- **TMC260-PA**
- **TMC260-PA-T**
- **TMC260-PA-X**

Product Change Notification

PCN-2016-06-04

June 4, 2016

Figure 1: TMC260 block diagram

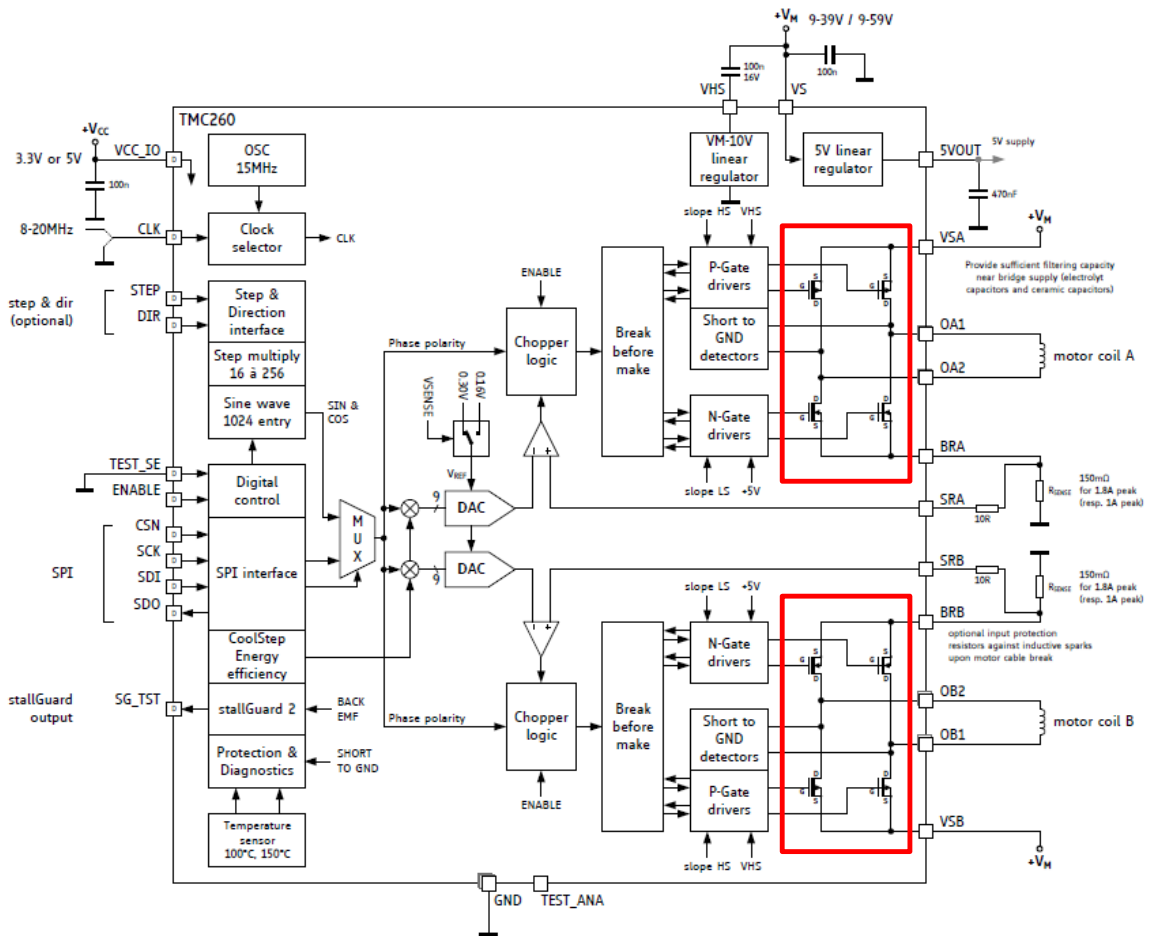
Due to product maintenance and to assure longevity of the TMC260 we qualified a new wafer fab for TMC260 motor driver MOSFETs full-bridges. Hardware changes:

- Motor driver N-channel MOSFET (4pcs. in total)
- Motor driver P-channel MOSFET (4pcs. in total)
- Revision field of IC label will change to "A". (TMC260 to TMC260A)
- New motor driver MOSFETs will improve power losses due to lower Rdson

You can find the relevant MOSFETs (red marked) in the block diagram in figure 1. Due to the multi-chip structure of the TMC260 only motor driver MOSFET dies are affected to the changes. Complete digital and analog part of the core die as well as lead frame and IC structure stays unchanged.
